Joystick Piloting for Outboard (JPO) Vessel Upgrade

NOTICE
Revised May 2018. This bulletin supersedes the previous bulletin number 2017-14 November 2017.
The bulletin includes revisions to the following procedures:
<ul style="list-style-type: none"> System Checklist

Green color paint dot

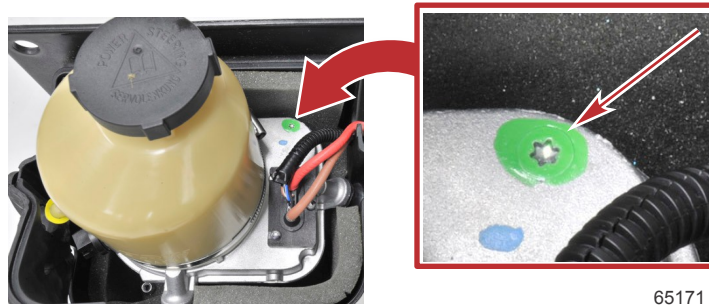
1. Remove the cover of the power steering pump.
2. Inspect the pump motor body for a green color paint dot. This dot will be located aft of the wire harness exiting the pump motor body. Refer to the following picture.

3. If the power steering pump body is not marked with a green color paint dot, a new power steering pump assembly must be ordered, installed, and the system purged of air. Refer to the appropriate service manual or installation manual on how to purge the power steering system of air.
